AGENDA
LANDMARK COMMISSION
REGULAR MEETING
4:00 p.m. Monday, April 3, 2023
City Council Chambers, 2nd Floor of City Hall
823 Rosenberg, Galveston, Texas

MINUTES OF THE LANDMARK COMMISSION OF THE CITY OF GALVESTON REGULAR MEETING – March 20, 2023

STAFF REPORT

Request for a Certificate of Appropriateness for modifications to the structure including enclosing the existing rear porch and adding a new rear porch.

14TH STREET - WEST ELEVATION

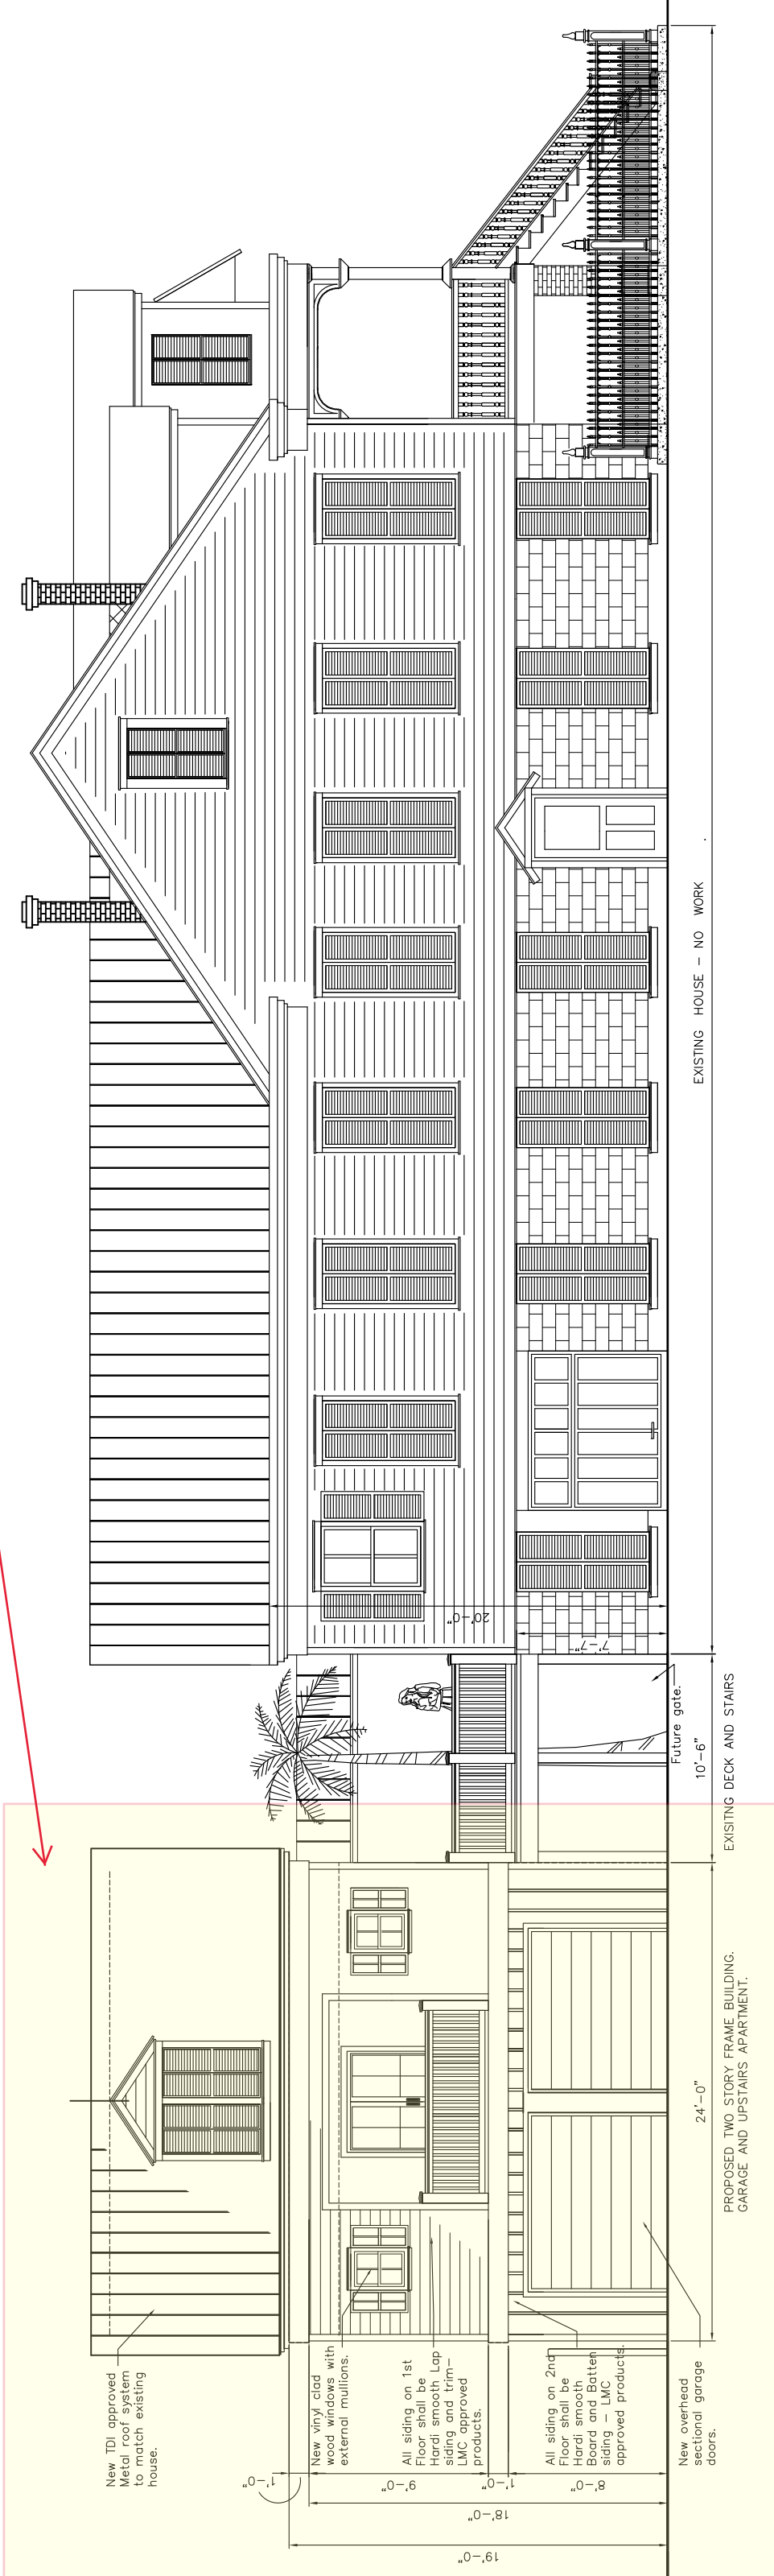
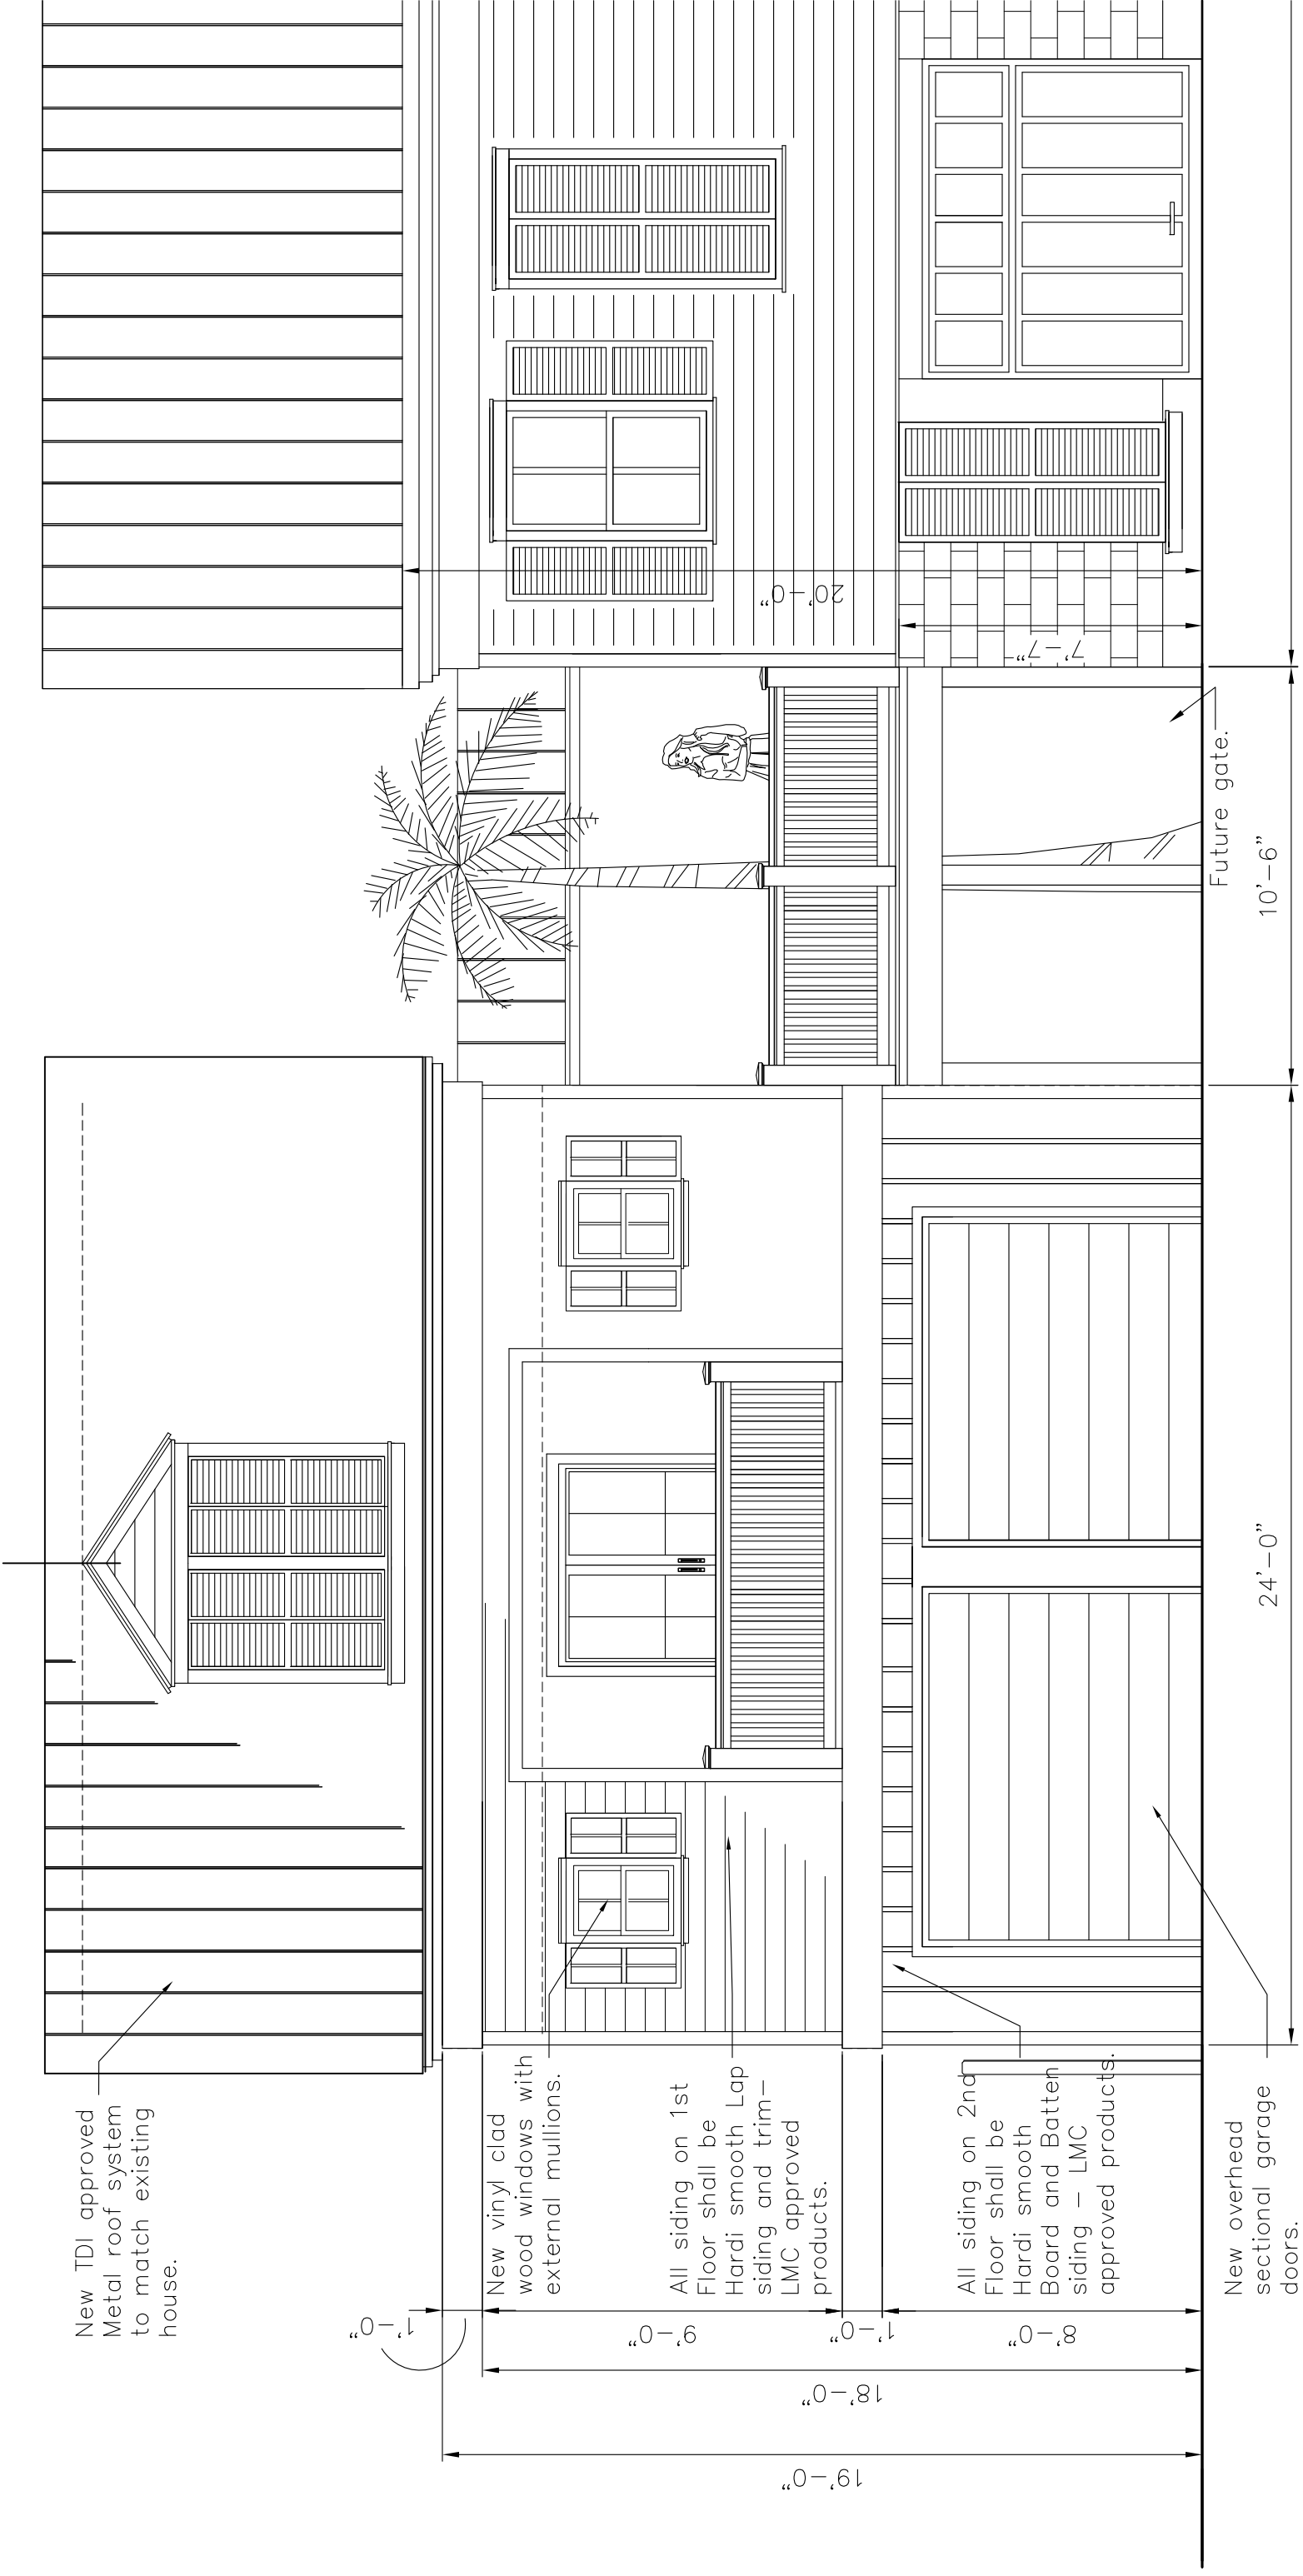
However, the request does not conform to the Design Standards regarding new driveways and garages, which are not allowed on a primary street. Staff recommends that the new driveway on 14th Street be omitted, and the garage doors be modified to access the alley directly behind. In addition, the proposed drawings depict windows with divided lights. While this is often appropriate for new windows added to historic homes, for new construction 1-over-1 windows are recommended by the Design Standards.

1. The exterior modifications shall conform to the design, materials and placement presented in Attachment A with the following modifications:
 - a. The proposed garage apartment shall be modified to provide automobile access (garage doors) from the alley only, and the proposed driveway onto 14th Street be likewise omitted;
 - b. Windows in the new addition shall be of a 1-over-1 light configuration;
